**14 CFR Part 36  
Noise Certification Regulations for  
Helicopters; Final Rule**

[Docket No. FAA-2000-7958; Amendment No. 36-25]

**Noise Certification Regulations for Helicopters**

ACTION: Final rule.

**Figure H1.**  
**Comparison of Measured and Reference Takeoff Profiles**

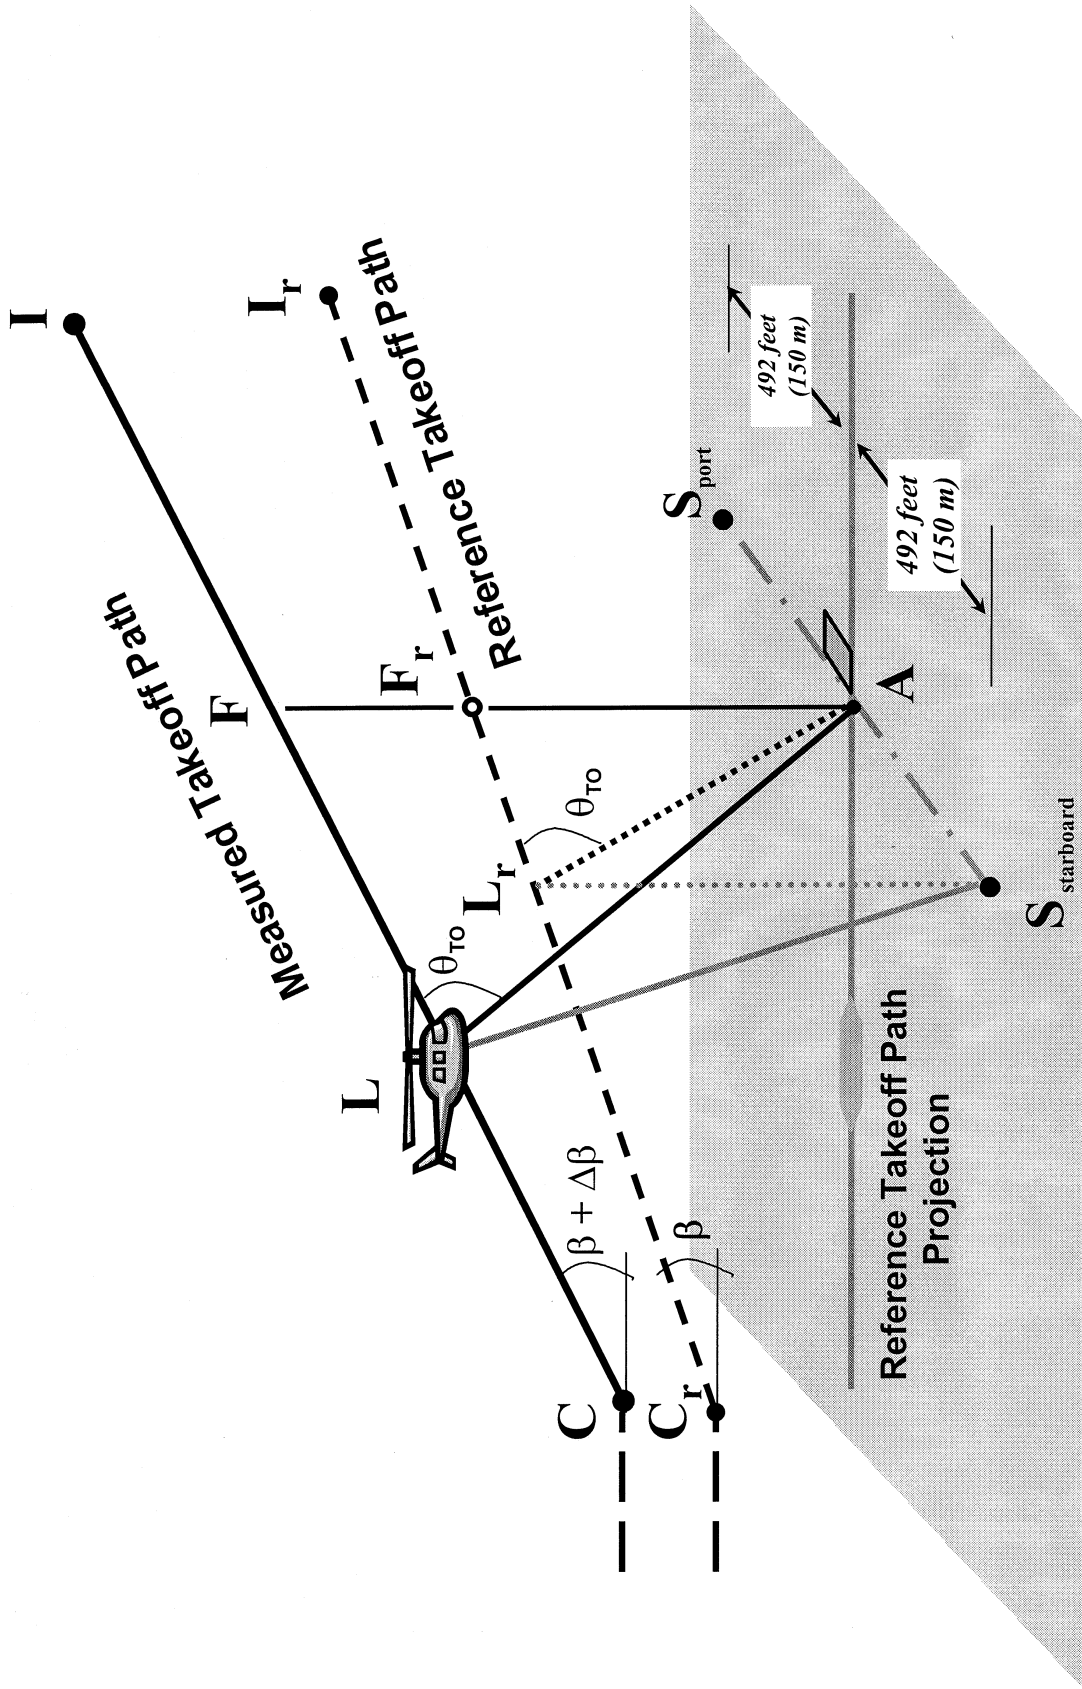
In Notice No. 00-12, the FAA proposed to revise Figures H1 and H3 to include the height above measurement points in metric units and to delete the closest point of approach (CPA) distance designations. The FAA received no comments on this proposal and it is being adopted as proposed.

Although Figure H2 changes were not addressed in the NPRM, for accuracy and completeness, the FAA is making corrections to typographical errors and replacing incomplete designations. The word "corrected" is replaced with the

word "reference" in the titles of Figures H1, H2 and H3 in the final rule. This change keeps the language in the final rule consistent throughout Appendix H.
